7 Water Resources

7.1 Stormwater Management

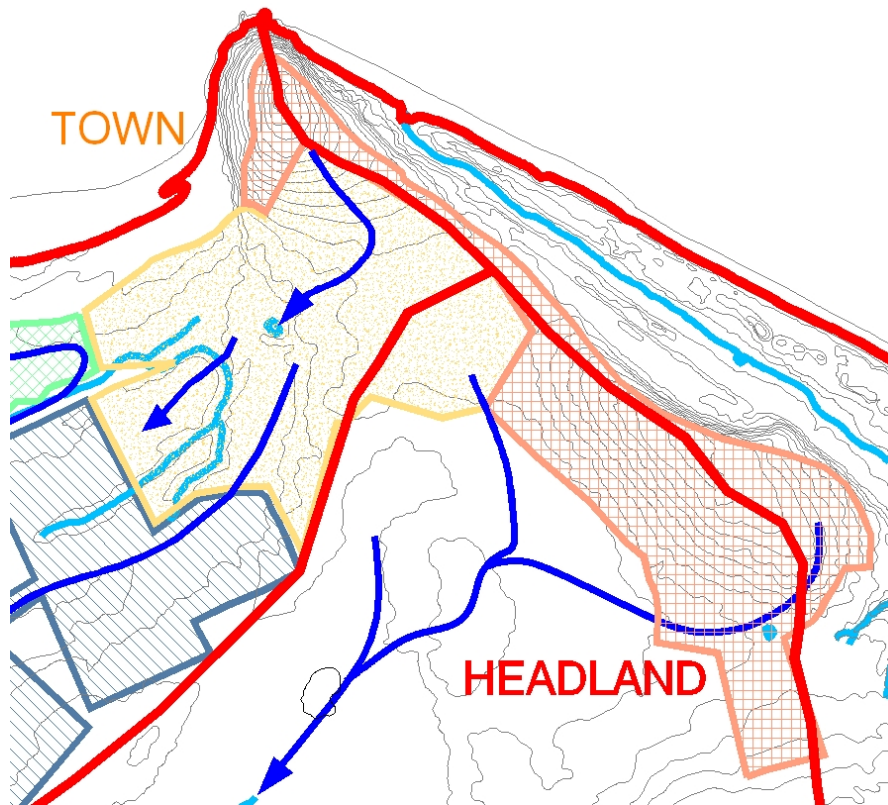
Several submissions expressed concerns around the potential impacts on sensitive coastal dune systems and on coral reefs just offshore from the headland as a result of construction and operation of a stormwater outlet structure at the north beach.

The proposed stormwater discharge at North Beach has been rerouted, and will now flow in a southerly direction into the Lagoon Zone and the dedicated detention there. This removes any discharge into the 'North Beach', Bay and Headland Zones and avoids any impacts to the coastal

dune and coral reefs. The figure on page 17 of the Stormwater Management Report has been updated to show the following:
